Re: License STC-133

**SUBJECT: Request for Additional Information Concerning
Application for Amendment to License Control Nos.
138087 and 138458**

RESPONSE TO COMMENTS
NRC/DNSC/ORISE/ORNL NOVEMBER 22, 2006
RAI FOLLOW-UP CONFERENCE CALL REGARDING
SITE-SPECIFIC DERIVED CONCENTRATION GUIDELINE LEVELS
FOR THE CURTIS BAY AND HAMMOND DEPOTS

Figure 2: Monitoring Well and Surface Water Sampling Locations (Radioactive Waste Site Monitoring Well Location is Shown in the 1999 Parsons Report Previously Provided)

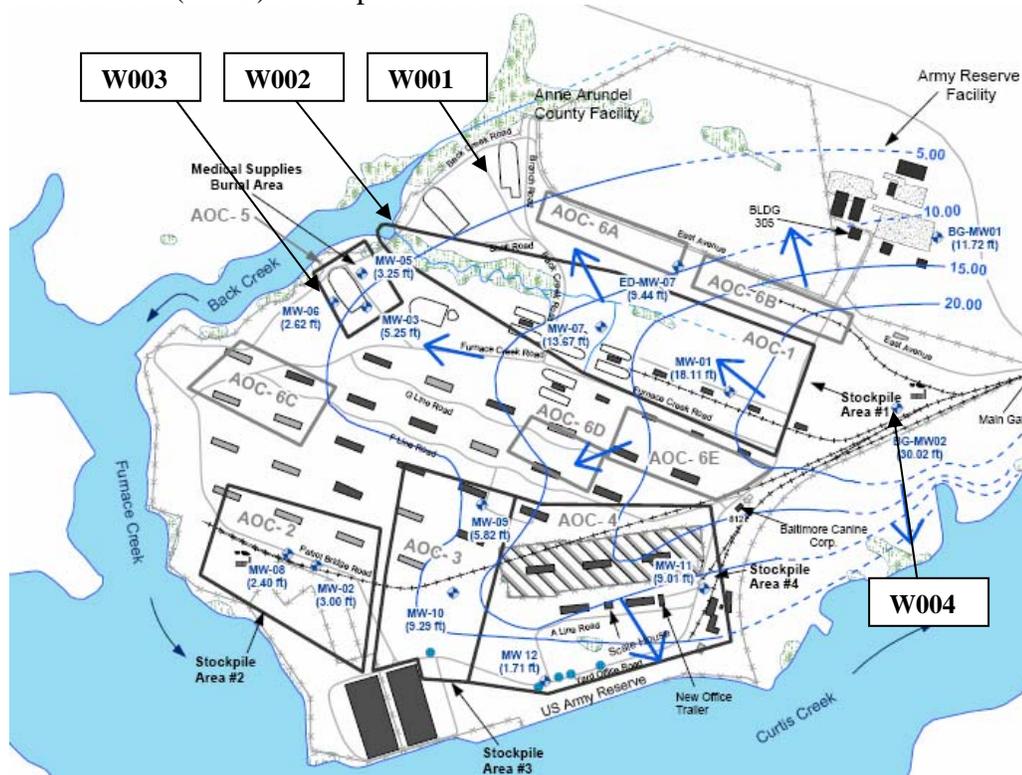
DLA should sample the groundwater well near the radioactive waste disposal site for radioisotopes of Th and U (depth to water and pH would also be useful information). DLA should provide any details regarding the groundwater well location (orientation with respect to the radioactive waste disposal site, groundwater flow direction, and expected surface water discharge points) and well screen depth in relation to the average water table elevation. DLA also indicated that it might take a surface water sample. The location should be just downgradient from the expected discharge point to surface water (e.g., along a reach of Furnace Creek).

DNCS Response: ORISE collected water samples from three groundwater wells and one surface water location on December 11, 2006. These wells included the monitoring well located within the boundaries of the former radiological waste disposal area (sample ID W001), one of the three monitoring wells (MW-06) installed to the southwest of the disposal area in the medical supplies burial area (sample ID W003), and one of the background monitoring wells (BG-MW02) installed on the eastern edge of the site (sample ID W004). A surface water sample was also collected from the small creek that flows into Back Creek (sample ID W002). Figure 2 shows monitoring wells and creeks (Parsons 2006). The monitoring well within the radiological waste disposal area is shown in the 1999 Parsons report (Parsons 1999). Samples were collected in accordance with ORISE procedures. The depth to the water table was recorded for each well

sampled. Each well was then purged an equivalent of three volumes prior to collecting the samples. The pH of each sample was determined in the ORISE laboratory prior to sample acidification and processing. Samples were analyzed by alpha spectroscopy for isotopic thorium and uranium. The results are provided in Table 1. All results were less than or equal to the minimum detectable concentration (MDC) of the procedure.

Furthermore, should groundwater percolate into the pit during remediation, samples will be collected at that time to verify that there has been no groundwater impact.
